COUNTRY BREEZE SUBDIVISION

The purpose of this application is to create a five-lot subdivision from a metes and bounds parcel.

APPLICATION NUMBER 15 DATE June 3, 2004

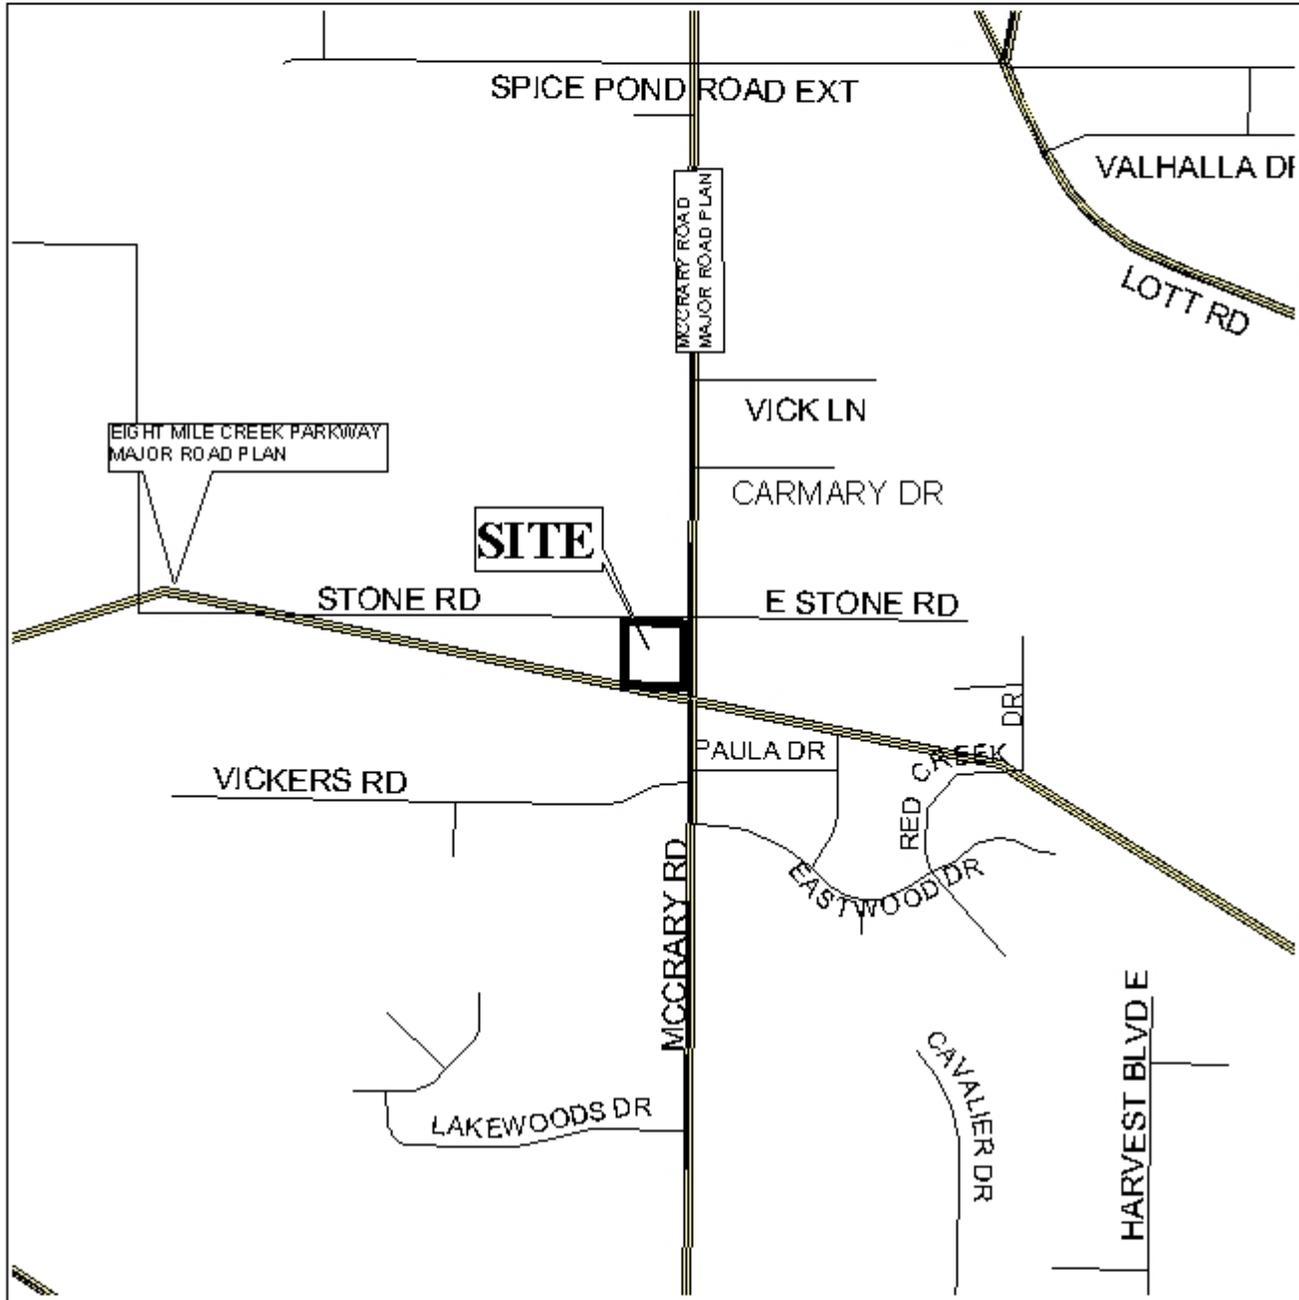
Engineering Comments: Must comply with the Mobile County Flood Damage Prevention Ordinance.

The plat illustrates the proposed 5 lot, 4.3 ± acres subdivision which is located at the Southwest corner of McCrary Road and Stone Road. The subdivision is served by public water and sanitary sewer from South Alabama Utilities.

Lots 2 through 5 front McCrary Road, a planned major street, with McCrary Road having an existing right-of-way shown as 80 feet. The Major Street Plan requires a 100-foot right-of-way, therefore, the setback of sufficient right-of-way to provide 75-feet from the centerline of McCrary Road should be provided. Additionally, as a means of access management, a note should be placed on the final plat stating that Lots 2 through 5 are limited to one curb cut each to McCrary Road, with the size, location and design to be approved by County Engineering.

The site is adjacent to the Eight Mile Creek Parkway as illustrated on the Major Street Plan. However, because the exact route of Eight Mile Creek Parkway has not been determined, the provision of setback or dedication would not be appropriate at this time. Additionally, the right-of-way required for the Eight Mile Creek Parkway is 200', which would be an excessive taking for a Subdivision of this size.

This site is located in the County, thus a note should be placed on the final plat stating that any lots which are developed commercially and adjoin residentially developed property must provide a buffer, in compliance with Section V.A.7. of the Subdivision Regulations.

The plat meets the minimum requirements of the Subdivision Regulations and is recommended for Tentative Approval subject to the following conditions: 1) the provision of a 75-foot setback (which includes the required minimum building setback of 25-feet) from the centerline of McCrary Road; 2) the placement of a note on the final plat stating that Lots 2 through 5 are limited to one curb cut each to McCrary Road, with the size, location and design to be approved by County Engineering; and 3) the placement of a note on the final plat stating that any lots which are developed commercially and adjoin residentially developed property must provide a buffer, in compliance with Section V.A.7. of the Subdivision Regulations.
